Stair flip study · the main stair turned round: start and arrival at the NORTH end, next to the lift · Taif / Palm House V8.0 (work) · STUDY ONLY

ADOPTED 2 Nov 2026 (owner): option B, the freed landing as F-b, the balustrade, the store door onto the riwaq, the half-landing window, the entrance side light, the entry cupboard removed; applied to the design files. Owner's idea, 1 Nov 2026 · the same well (2.75 × 5.7 on axes, 2.525 × 5.50 clear), the same 22 risers × 0.164 / goings 0.28, flights 1.21 clear · nothing in the design files changes until the owner decides · all sizes assumed

1 · The two options on the ground floor

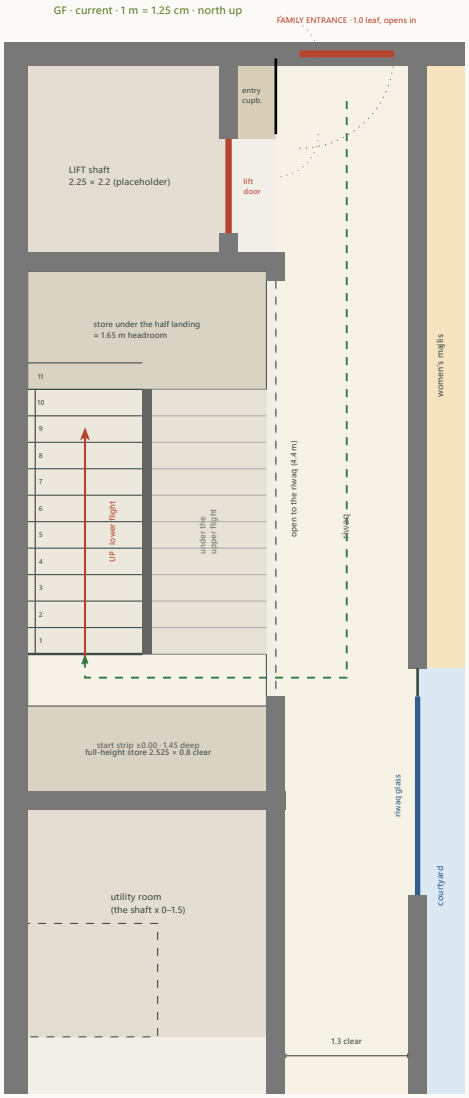
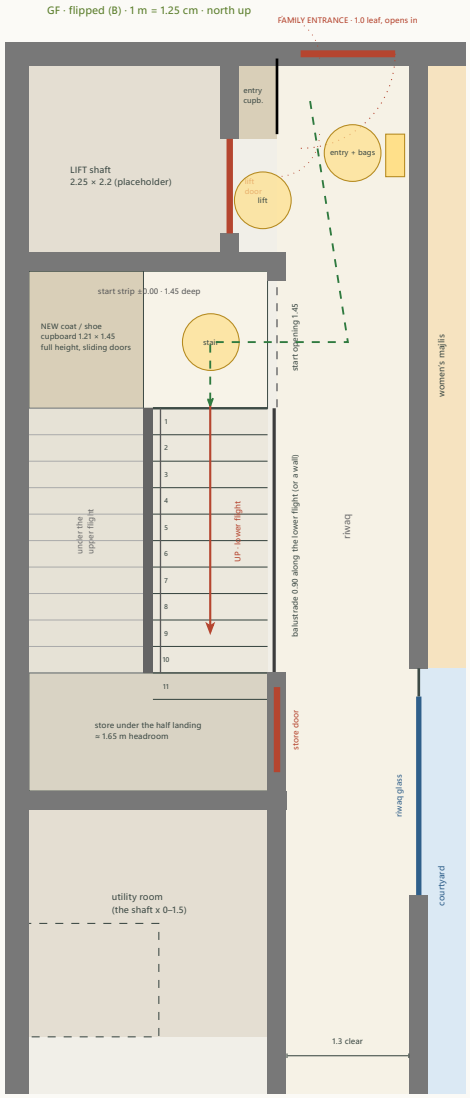
- **Current:** the lower flight on the **west** half starts at the **south** end (first riser y 6.35); the person comes along the riwaq, enters the well through its open east side (4.4 m open) and turns west onto the flight; in front of the first riser only **0.55 m** before the full-height store's wall (the start is really made from the side, under the upper flight's high end). Half landing at the north end (+1.80, a 1.65 m store below it, opening east onto the riwaq); the full-height store 2.525 × 0.8 clear at the south end.

- **Flipped (B, recommended of the two flips):** the lower flight on the **east** half starts at the **north** end (first riser y 3.75), **straight off the lobby**: a 1.45 m opening in the x 2.75 line between the lift notch and the flight, a start strip 1.45 m deep in front of the first riser. The lower flight rises along the riwaq side (a 0.90 balustrade on the riwaq, or a wall: the owner's choice); the half landing at the south end with its 1.65 m store (door onto the riwaq at y 6.7–7.6, in front of the courtyard glass; or into the utility room). The **west half of the start strip** (1.21 × 1.45, full height) becomes a **coat / shoe cupboard** beside the family entrance (sliding doors onto the strip).

- **Flipped (A):** the mirror image only (the lower flight stays west): the person crosses the whole strip to the far half before climbing; no cupboard. Not recommended; everything else below holds for both.

2 · Congestion test at the flipped start (drawn)

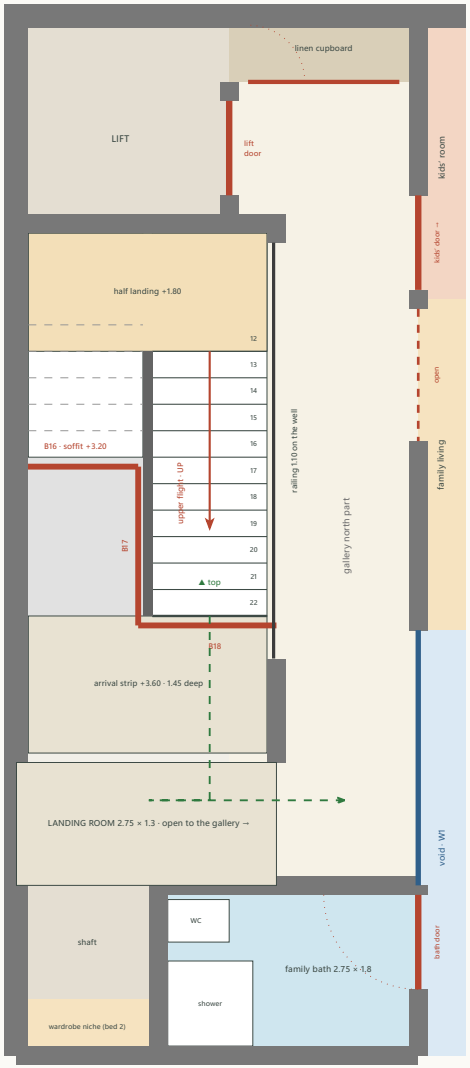
Three people at once: **one waiting for the lift** in the 0.50 m notch in front of its sliding door, **one coming in with bags** inside the family entrance's 1.0 m swing, **one starting up the stair** on the start strip, with the **entry cupboard's two 0.45 leaves open** into the lobby. Clear widths, not axes: the lobby **1.3 m** between the lift / cupboard wall face and the women's majlis wall face (the notch adds 0.5 m at y 0.9–2.2); the start opening **1.45 m**; the first riser **1.21 m** wide; the entrance **0.9 m** clear. The three stand in three separate zones along the lobby (y 0–1.0 the door swing, y 0.9–2.2 the lift notch, y 2.3–3.75 the start strip); the stair starter passes 0.3 m south of the lift waiter and never crosses the entrance swing: **OK**. Two people can pass in the 1.30 m lobby (0.60 + 0.60 + 0.10) but a person with two bags blocks it for a moment, as today. **Furniture up the stair:** the 90° turn from the 1.30 lobby through the 1.45 opening onto the 1.21 flight is a tight but normal house stair turn; the current start (0.55 m strip, sideways) is worse.

FF · current · 1 m = 1.25 cm · white = opening · grey = slab

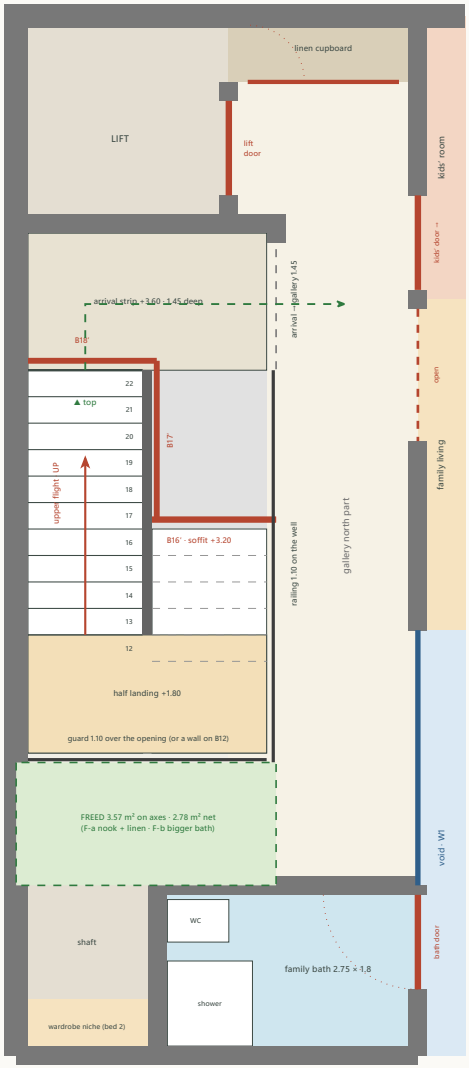
- **Current:** the upper flight (east half) lands at +3.60 on the arrival strip (y 6.35–7.8), then the **landing room** (2.75 × 1.3, y 7.9–9.2) and east into the gallery; the bedrooms and the family bath are at hand, the kids' room, the living and the lift are 6–9 m north along the gallery.

- **Flipped (B):** the upper flight (west half) lands on the arrival strip at the **north** end (y 2.3–3.75); the strip opens east onto the gallery's north part (1.45 m), **0.10 m south of the lift notch**: the lift's first-floor door, the linen cupboard (its leaves swing south, 0.6 m), the kids' room door (opens into the room) and the family living's opening are all within 1–3 m. The gallery's north part (1.30 clear) carries the arrival traffic as it carries the lift's today; the linen leaves and the lift door are 1.0 m north of the arrival: no clash. The railing on the well runs from the arrival (y 3.75) to the south wall; the landing room is **freed** (§ 5).

- **Current (studies/structure.typ):** an L-shaped opening ≈ 8.2 m²: the west half open from the north wall to B16 (y 4.85), the east half open to B18 (y 6.45); B16 (0.20 × 0.40, soffit +3.20) from the west wall to B17; B17 (x 1.29, on the lower flight's side of the split) from B16 to B18; B18 (y 6.45) from B17 to the riwaq-line beam B10 (x 2.75).

- **Flipped (B):** the **same opening turned round** (≈ 8.2 m²): the east half open from B16′ (y 5.33) to the south wall, the west half from B18′ (y 3.65) to the south wall. **B16′** (y 5.33) from the riwaq-line beam B10 to B17′; **B17′** (x 1.49, on the east, lower flight's side of the split: never over the upper flight) from B16′ to B18′; **B18′** (y 3.65, the arrival edge) from the west wall to B17′. The same zigzag, mirrored: one beam-on-beam junction at each end of B17′, the torsion the engineer's; B18′ now bears on the west wall (as B16 does today) and B16′ on B10 (as B18 does today). **Neither better nor worse** for the structure: the spans (1.3–1.6 m) and the bearings are the same kind. **Not verified.**

- **Slab edges:** the arrival strip (1.45 × 2.525) spans between the north wall beam B11 (y 2.2) and B18′; over the lower flight's first six treads the slab spans from B18′ to B16′ (1.6 m) between B10 and B17′. The guard round the opening: the railing on x 2.75 from the arrival south to y 7.9, the well's south wall line y 7.9 (a 1.10 guard or a wall on B12), the upper flight's balustrade on the split.

current · section along the lower flight, looking east · 1 m = 1 cm

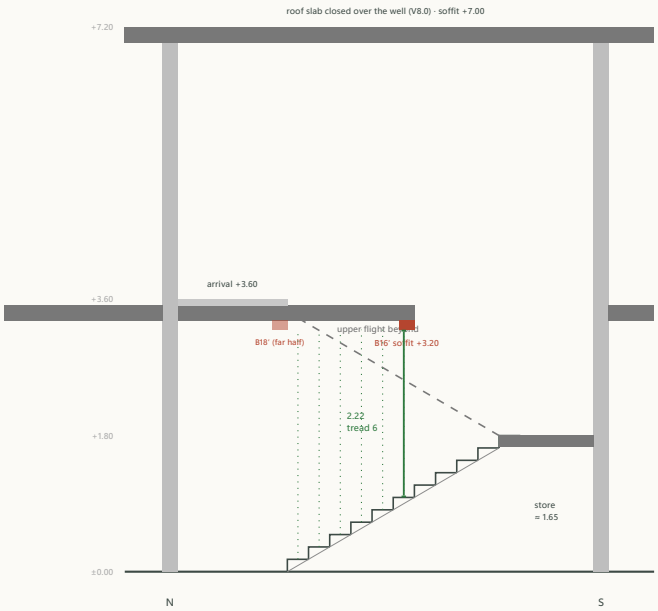
The upper flight, the half landing and the arrival are under the open well (the roof slab's soffit +7.00): ≥ 3.4 m. Minimum of this option: **2.22 m** at tread 6 under the trimmer, across the whole 1.21 m width (the trimmer spans the half); B17 over the inner 0.10 strip of treads 1–5: ≥ 2.38 m.

The upper flight, the half landing and the arrival are under the open well (the roof slab's soffit +7.00): ≥ 3.4 m. Minimum of this option: **2.22 m** at tread 6 under the trimmer, across the whole 1.21 m width (the trimmer spans the half); B17′ over the inner 0.10 strip of treads 1–5: ≥ 2.38 m.

Verdict on the headroom: identical in both options (**2.22 m** at tread 6 under the trimmer, 2.83 m at tread 3 under the slab; ≥ 2.10 required, the 2.20 aim just met) because the flip mirrors the geometry: the trimmers sit in the same places relative to the treads. **The flip neither improves nor worsens the trimmers.** What would improve both: trimmers 0.20 × **0.30** (soffit +3.30 → **2.32 m** at tread 6) if the engineer accepts a 0.30 depth for the 1.3–1.6 m spans, or the slab edge moved one tread (the opening 0.28 m longer, ≈ 0.35 m² more void, tread 6 under open sky → the minimum moves to tread 5: 2.38 m). Both options can take either. The walls' handrails run the full flights (0.08 off the walls); the central handrail on the 0.10 split.
